ADDENDUM # 001

ST. CLAIR CATHOLIC DISTRICT SCHOOL BOARD
ST. JOHN FISHER CATHOLIC SCHOOL

TENDER NO.: 632-CP1505

Issue Date:
Wednesday May 13, 2015

A101 –ENLARGE FLOOR PLANS, INT. ELEVATIONS & DETAIL

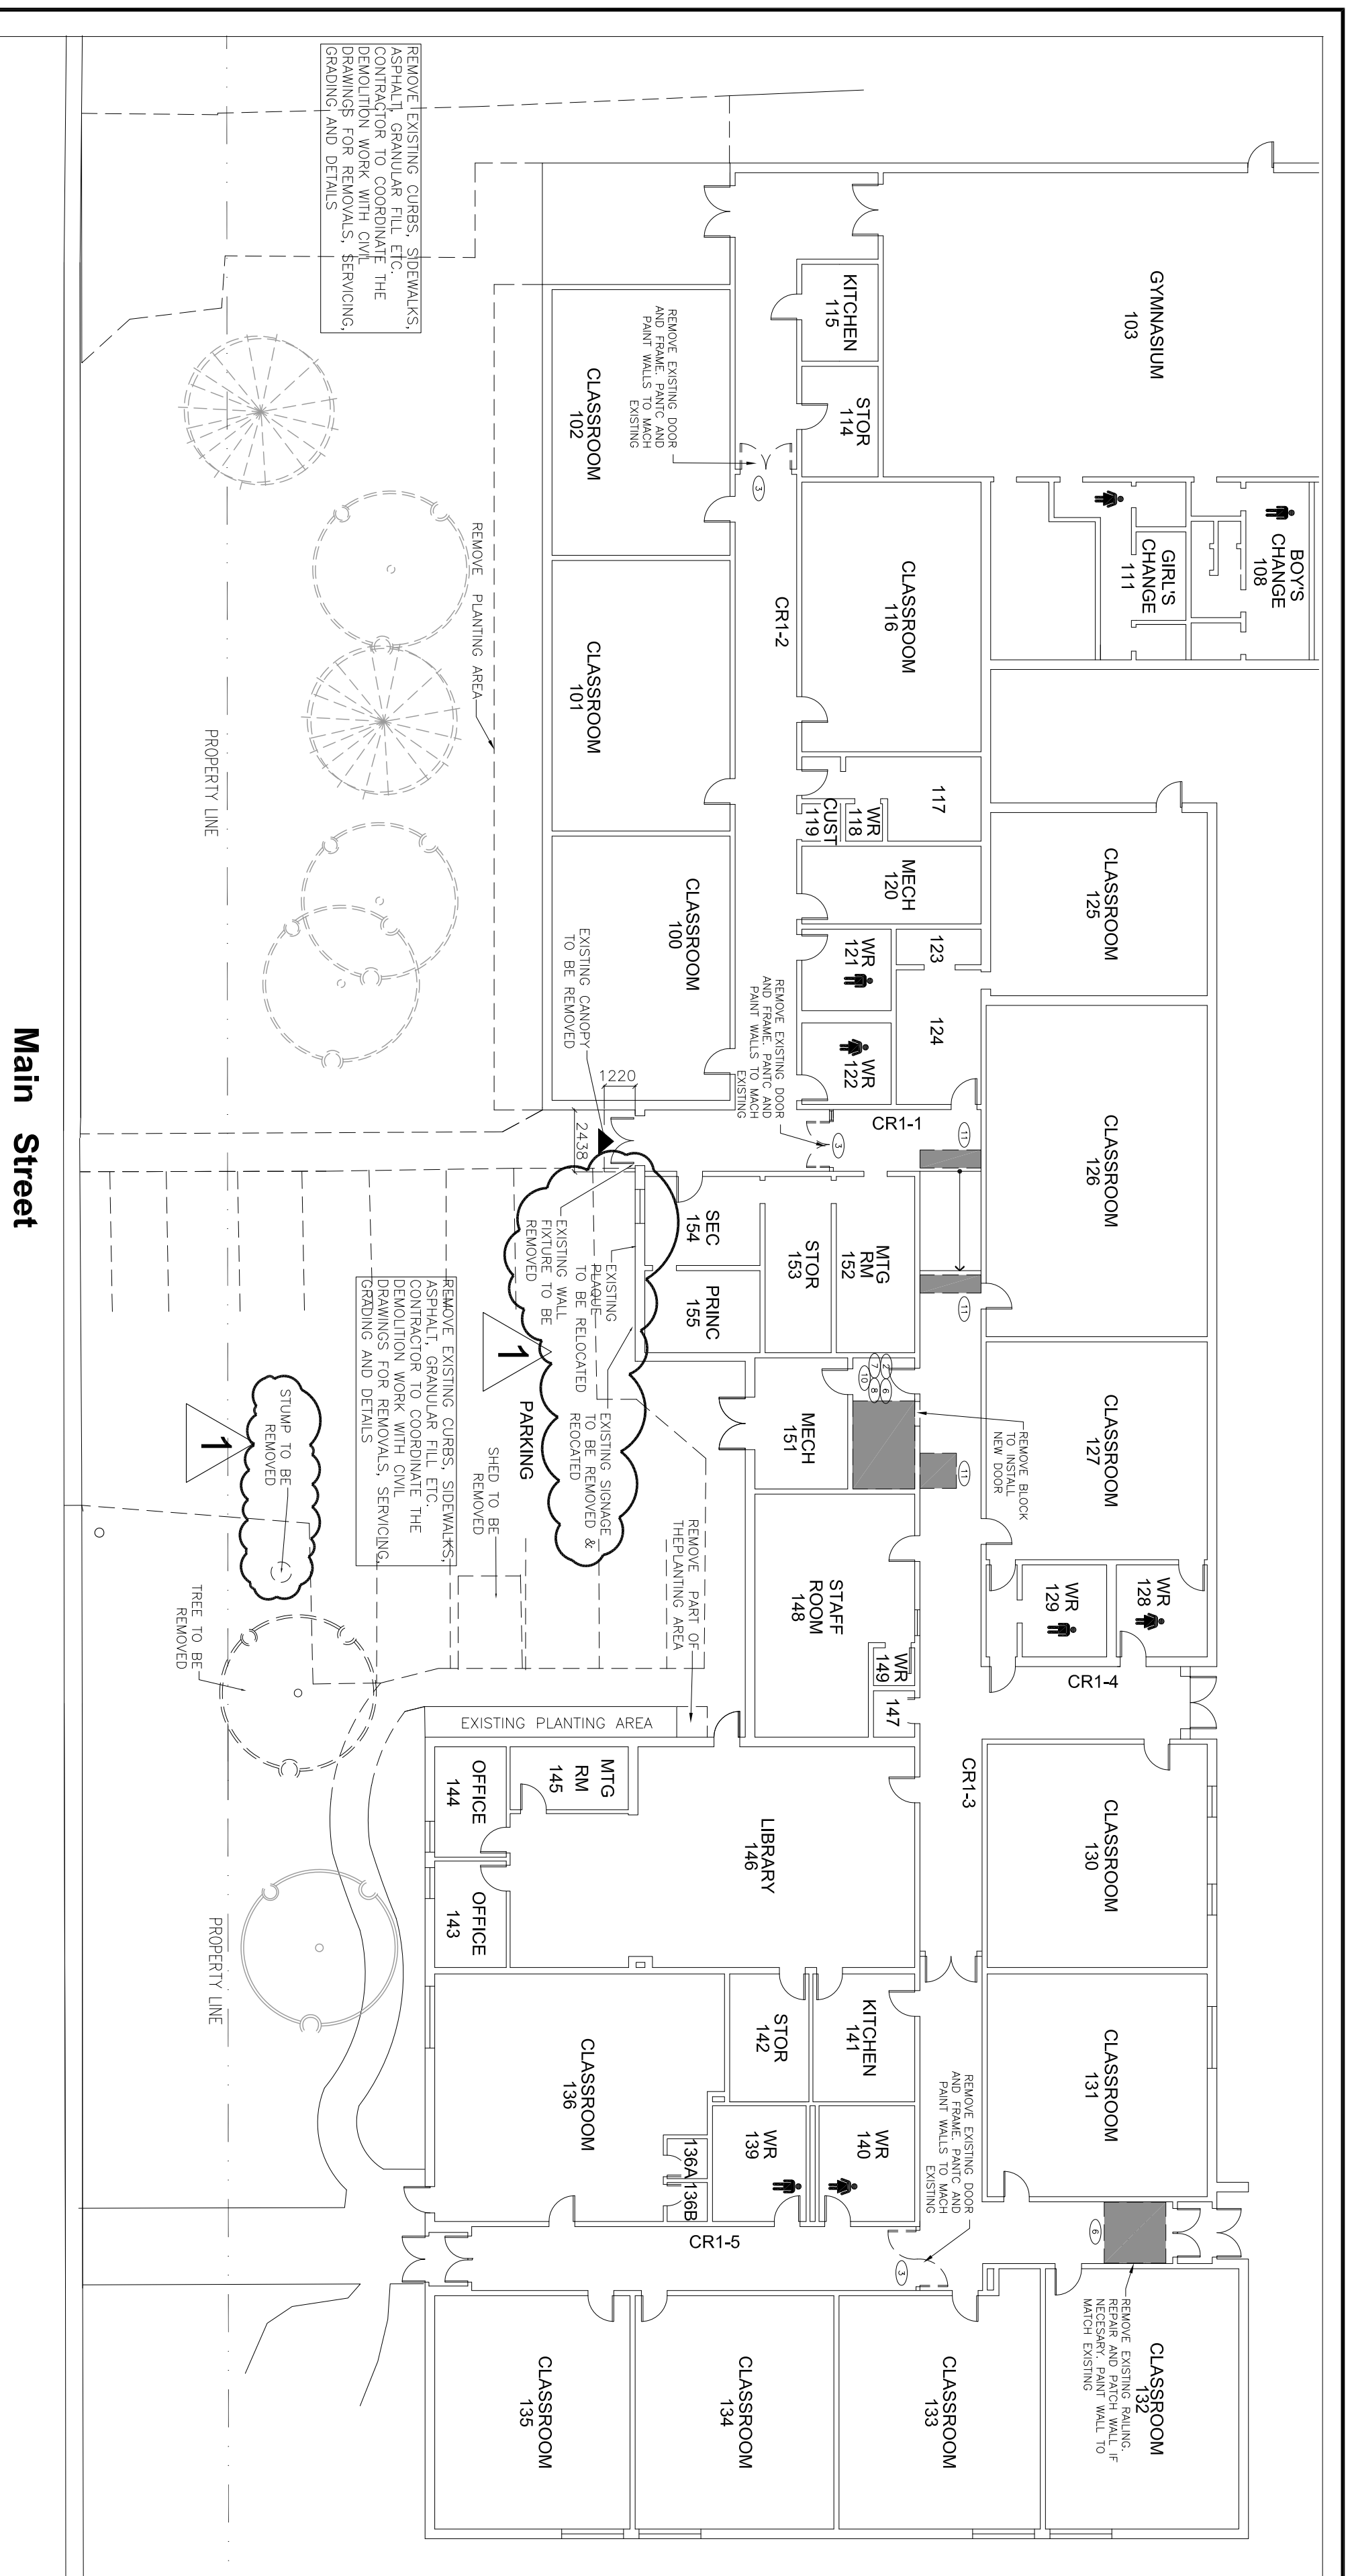
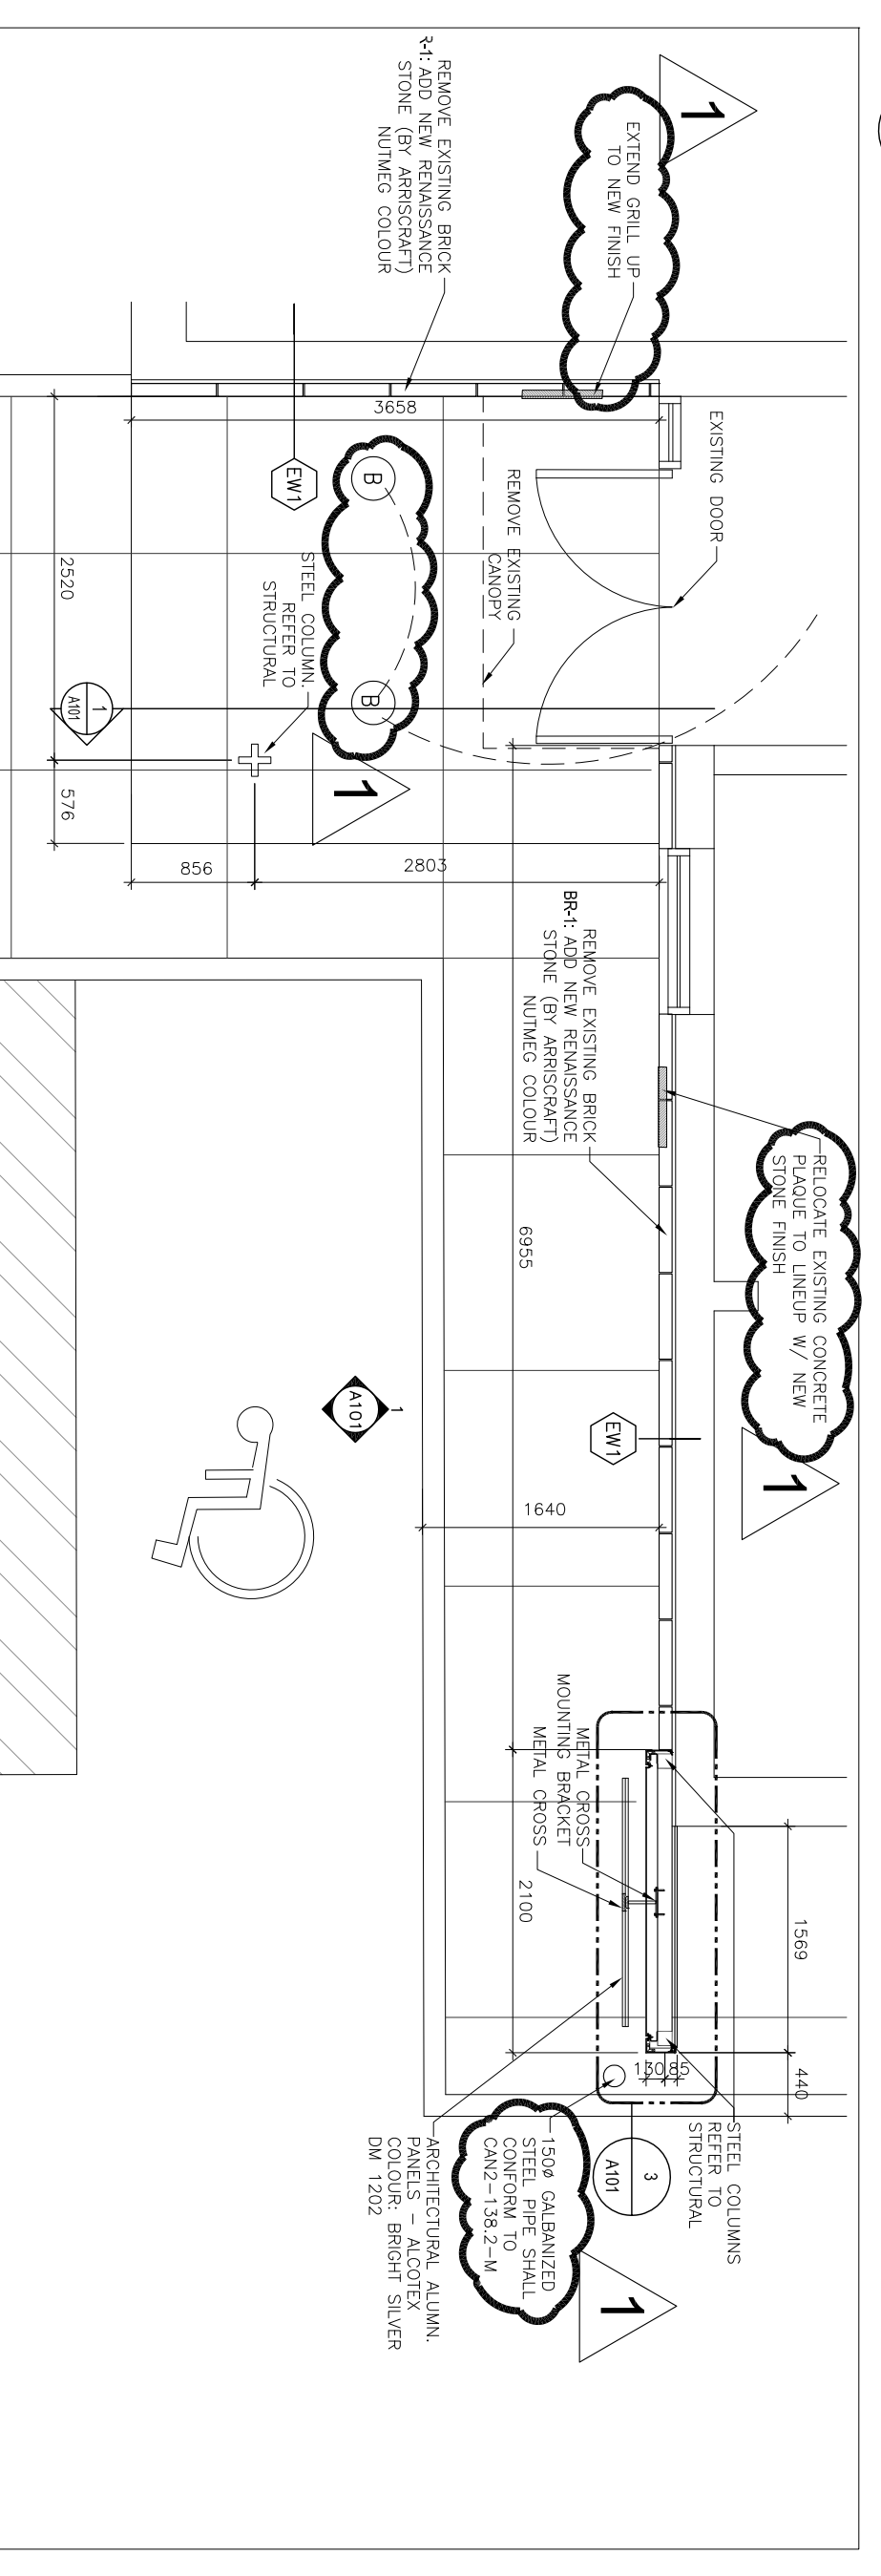
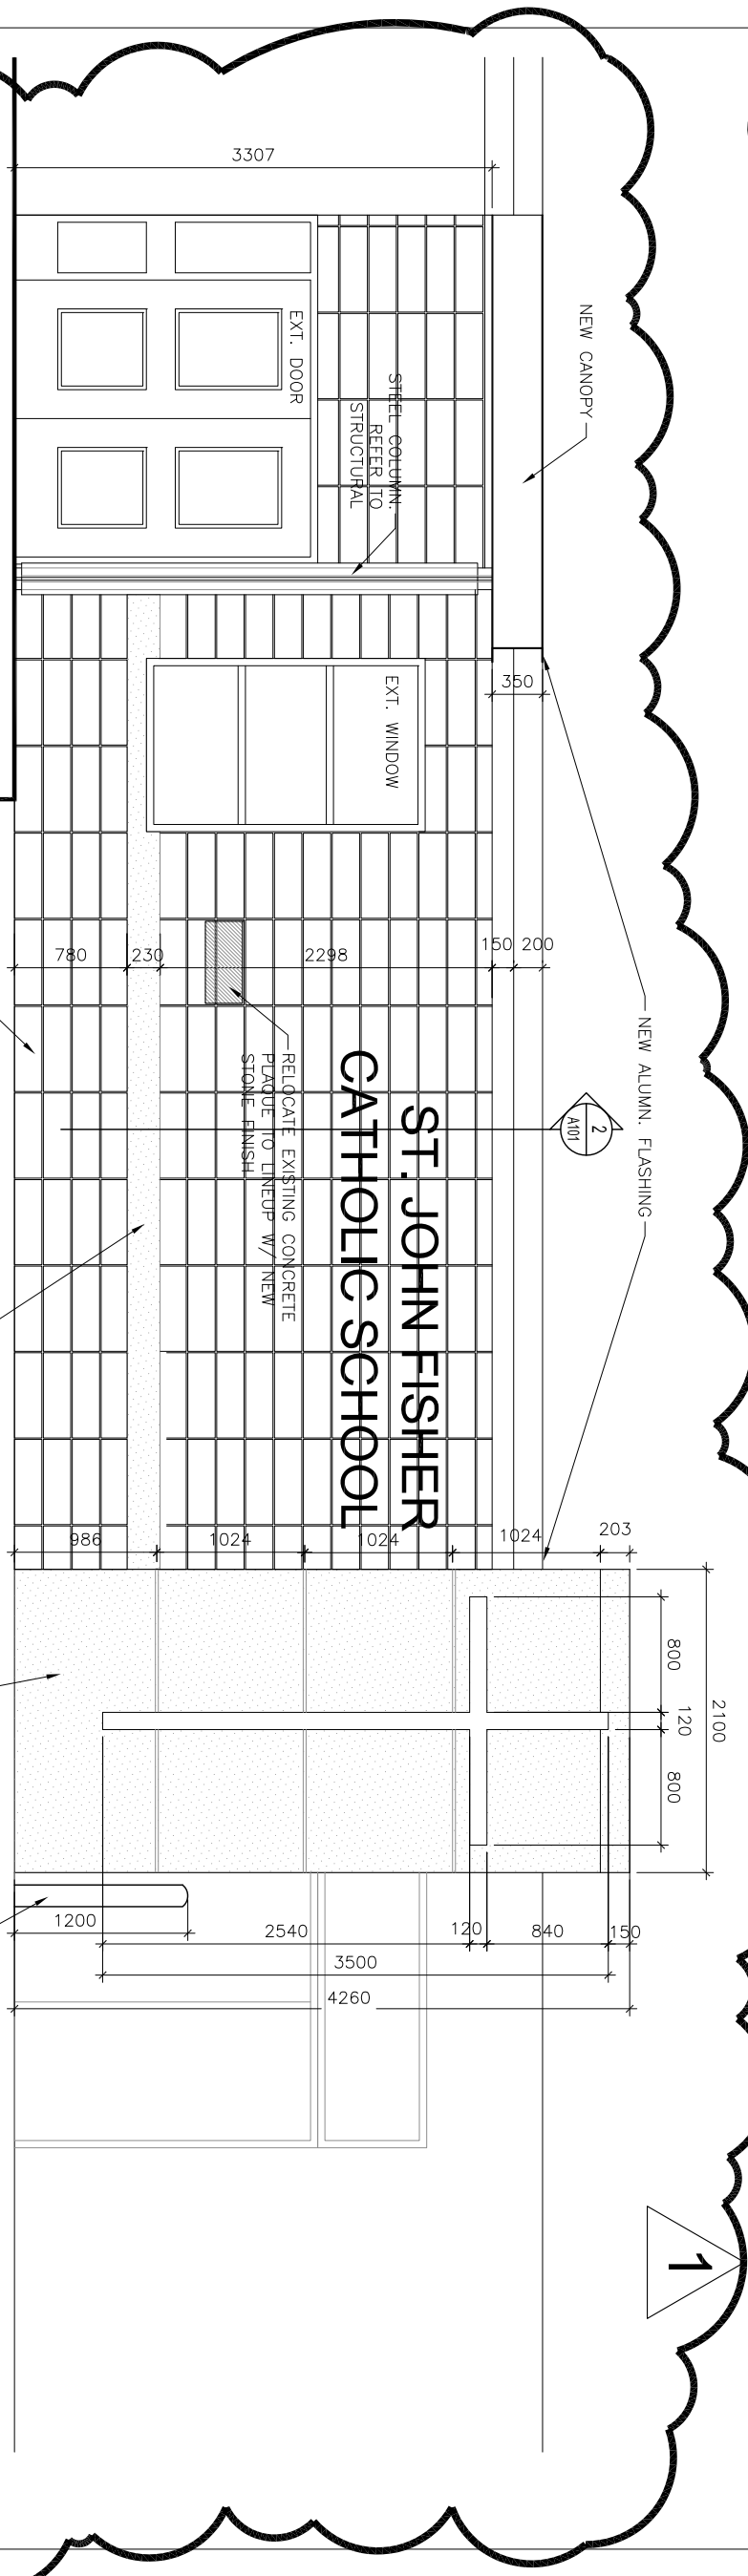
Refer to revision clouds and addendum 1 tags for changes to drawing.
